Report: TAB REPORT
Function: Test, Adjust, & Balance
Date: 05/22/2025
Completed By: National TAB

PROJECT
05-19-25 CAVA CHARLOTTE, NC
(NORTHLAKE)

Project: 05-19-25 CAVA CHARLOTTE, NC (NORTHLAKE)

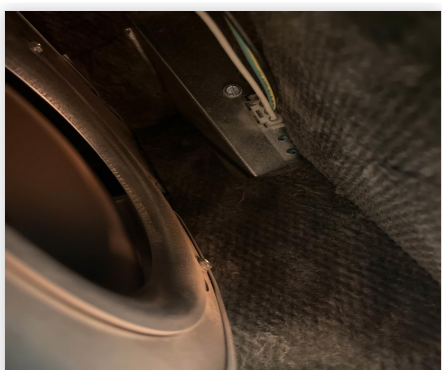
Issue Name : CEF1 & CEF2 / Speed Controllers
Description : CEF1 & CEF2 speed controllers are not installed. Unable to balance fans to design CFM.
Created By : National TAB **Assigned To :** National TAB - Dale Wheeler
Status : Open
Priority : High **Asset Tag :**
Originated Date : 05/20/2025 - Dale Wheeler - National TAB

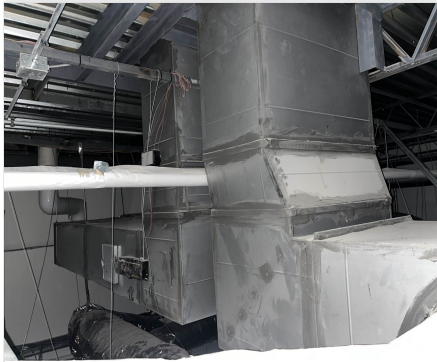
Issue Name : MAU / Gas Pipe Connection Leak
Description : MAU gas pipe connection is leaking gas. Heater is unable to be tested. Gas valve's for MAU, RTU1, RTU2 were in the off position upon arrival.
Created By : National TAB **Assigned To :** National TAB - Dale Wheeler
Status : Open
Priority : Medium **Asset Tag :**
Originated Date : 05/20/2025 - Dale Wheeler - National TAB
